Re: FCC ID NATTX433TS-2
Applicant: SmarTire Systems Inc
Correspondence Reference Number: 18481
731 Confirmation Number: EA100081

The following answers are submitted in response to your two questions.

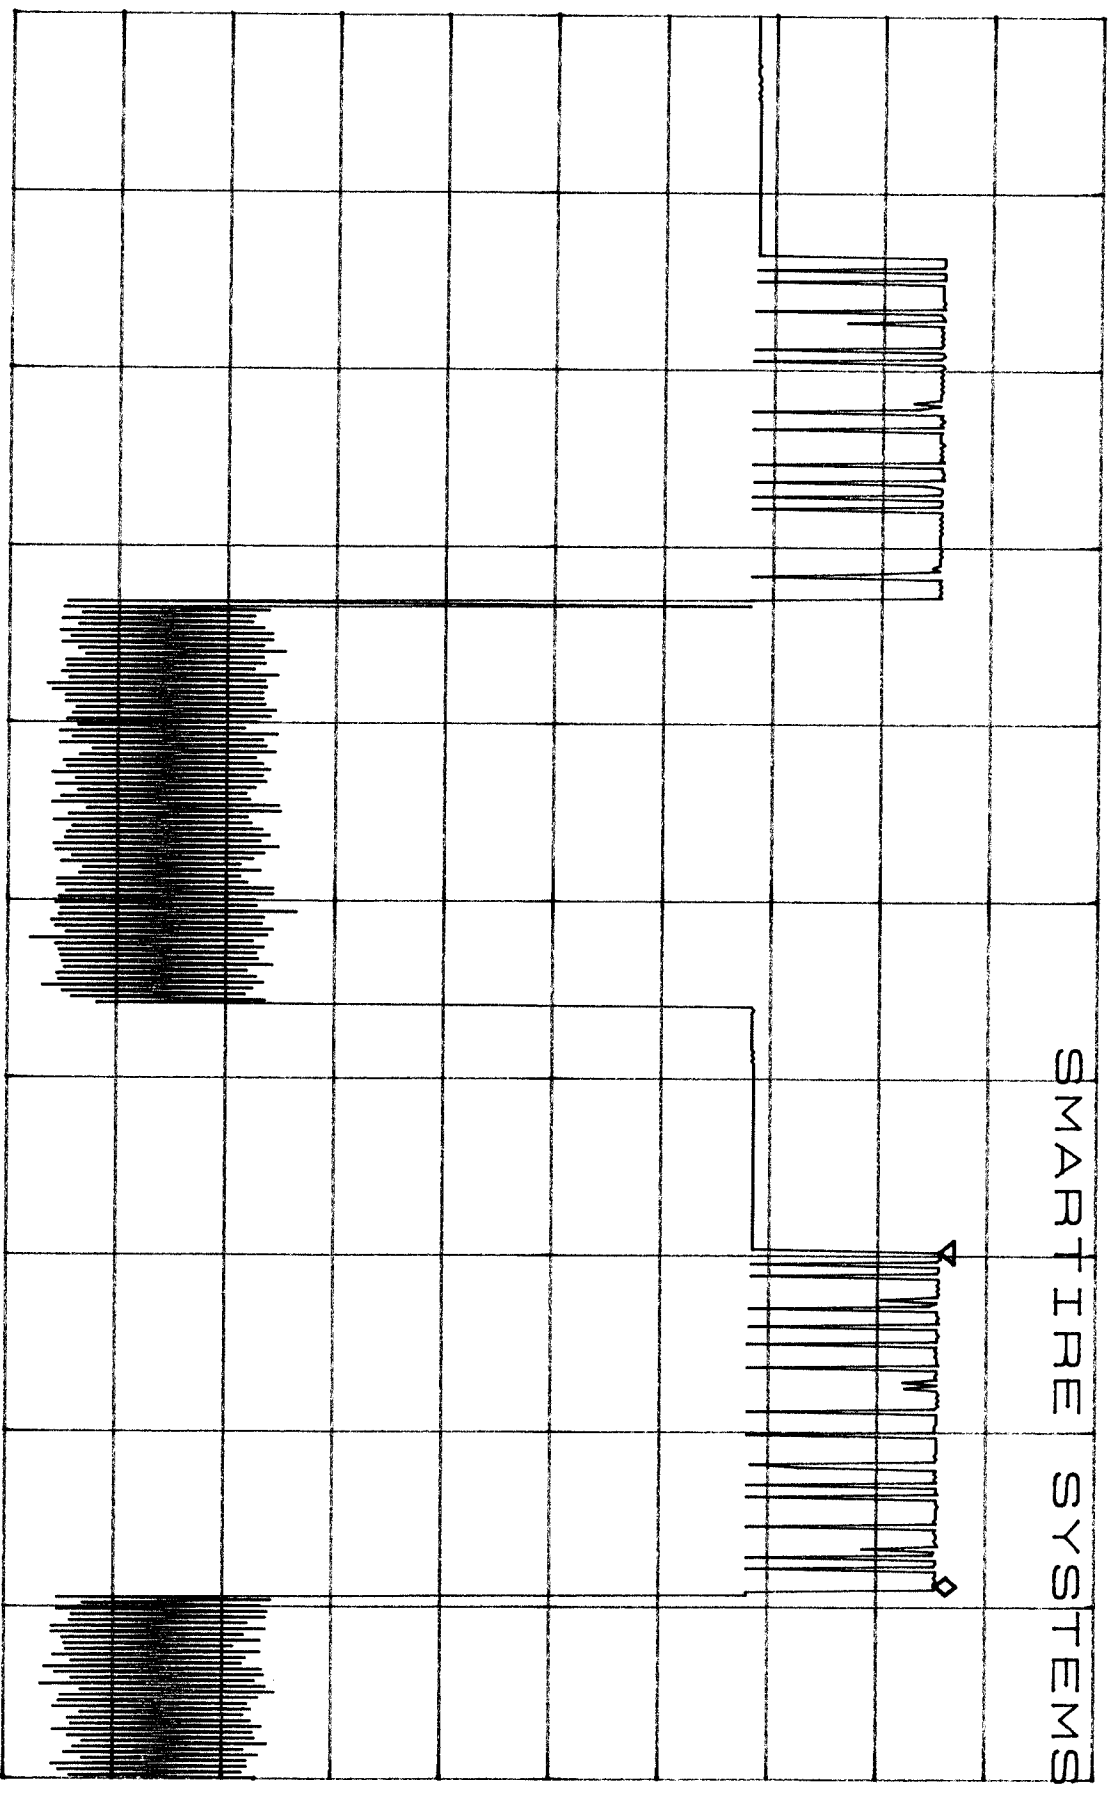
2). Submit time domain plots from which the duty cycle correction factor may be calculated.

The time domain plot is on the page following. If you would like greater detail I can submit the TRW datagrams that contain eight pages of details for the components used.

The sensor transmits 10 packets of data with each packet length 18.5 ms within 500 ms. every 4 – 6 minutes. So typically 2 packets in 100 ms period with a total packet length of 37 ms in 100 ms. With the BiPhase 50% on off duty cycle the EUT total on time in 100 ms then is 18.5 %. ($18.5 \text{ ms} + 18.5 \text{ ms} = 37 \text{ ms}$ total packet length at a 50% duty cycle = $18.5\% / 100 \text{ ms}$). Note the marker shows 19 ms which is within the range of instrument error with a 100 ms sweep.
